Access Compliance Report

Public Rights-of-Way

(Curb Ramps)

Intersection ID: 3828	Main Street: DAVIS_LAKE_PY	Cross Street: OLD_FOX_TL	Location: SW
ADA ID: EEA233C026C0	Ramp Type: Perp	Initial Pass/Fail: Fail	Overall Compliance: No
Severity Score: 12.5			
Codes/Mitigation Info/Possible Solution		Field Measurements/Component Compliance

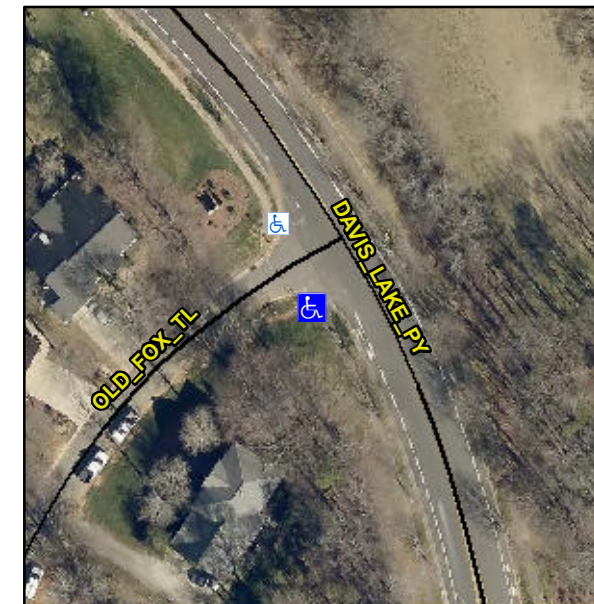
Not Found, R304.2.2

Compliance	Description	Data	Compliance	Description	Data
N/A	Ramp Length (in)	48.0	No	Ramp Slope (%)	8.4
Yes	Ramp Width (in)	64.0	Yes	Ramp XSlope (%)	0.7
N/A	Flare Type LT	N/A	N/A	Flare Type RT	N/A
N/A	Flare Slope LT (%)	N/A	N/A	Flare Slope RT (%)	N/A
N/A	Flare Traversable LT?	N/A	N/A	Flare Traversable RT?	N/A
N/A	Landing Length (in)	N/A	N/A	DWS Provided?	N/A
N/A	Landing Width (in)	N/A	N/A	DWS Contrast?	N/A
N/A	Landing Slope (%)	N/A	N/A	DWS Length (in)	N/A
N/A	Landing X Slope (%)	N/A	N/A	DWS Full Width?	N/A
N/A	Landing Curb? (Y/N)	N/A	N/A	DWS Offset (in)	N/A
N/A	Shared Landing?	N/A			
N/A	Gutter Ponding?	N/A	N/A	Gutter Slope (%)	N/A
N/A	Gutter Lip Ht (in)	N/A	N/A	Gutter X Slope (%)	N/A
N/A	Painted X Walk1?	No	N/A	Painted X Walk2?	N/A
	X Walk 1 Direction	To N		X Walk 2 Direction	N/A
N/A	X Walk 1 Width (in)	N/A	N/A	X Walk 2 Width (in)	N/A
	X Walk 1 Slope (%)	8.8		X Walk 2 Slope (%)	N/A
	X Walk 1 X Slope (%)	0.3		X Walk 2 X Slope (%)	N/A

Remove & Replace Entire Ramp.
